Project: Breehorn 41 rudder shaft
2012 version

Filename Breehorn 41 rudder
(dwg)

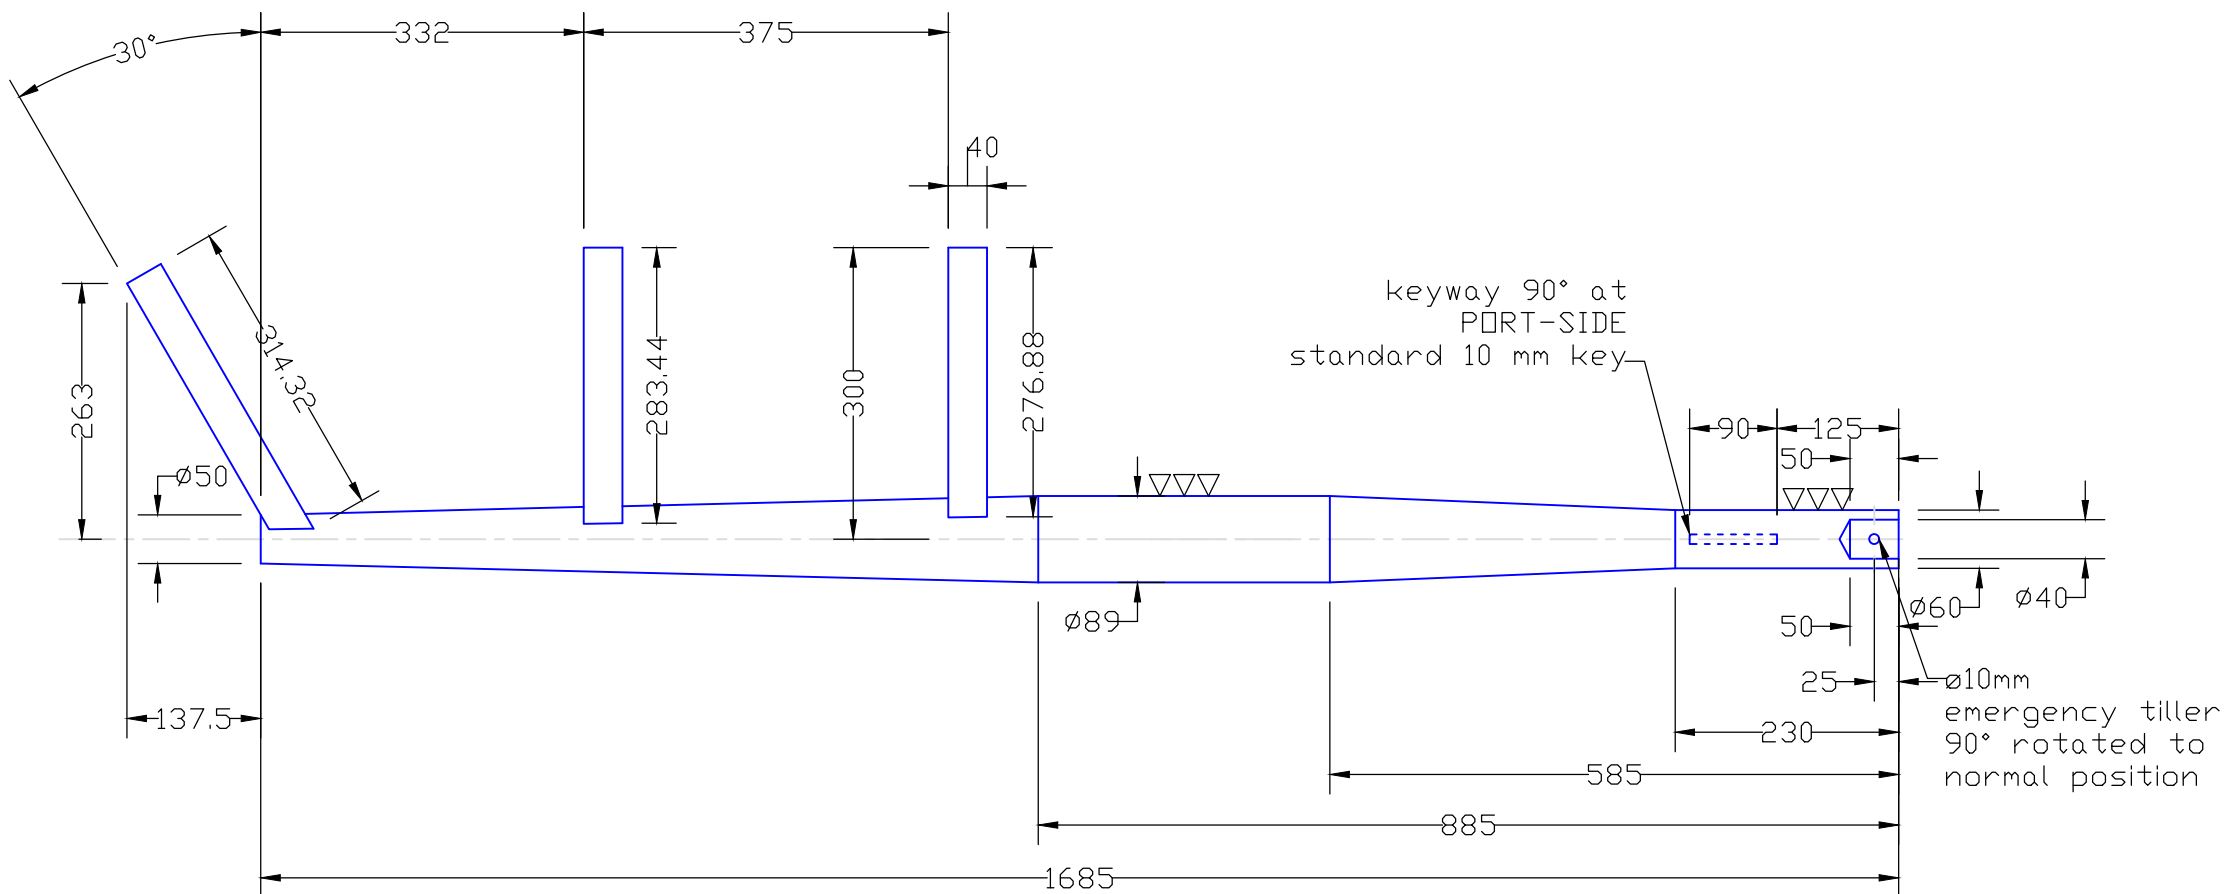
Modify date
10.11.2006 new version of shaft from customer Megens
onwards. Ø78 mm to Ø89 mm due to larger blade
